## Product Change Notice

Issue Date: 22-March-2022

New yellow dice replacement for Leadframe Seven Segment Display and Annunciator.

*Label for current die*

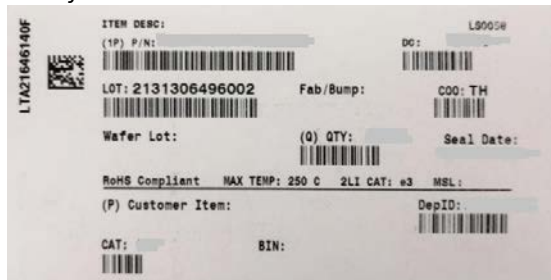
Shipment may contain product from current die and new die starting 1 Aug 2022 until the inventory of current die is fully depleted. There will be no mixed die within the same tube/ lot.

*Label for new die*

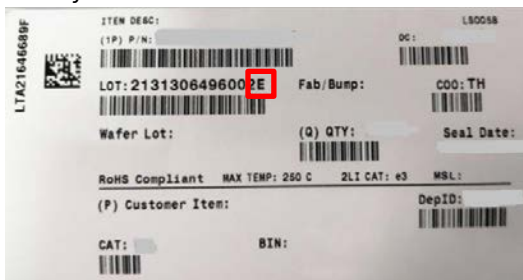
Prefix "E" will be added to the Lot number
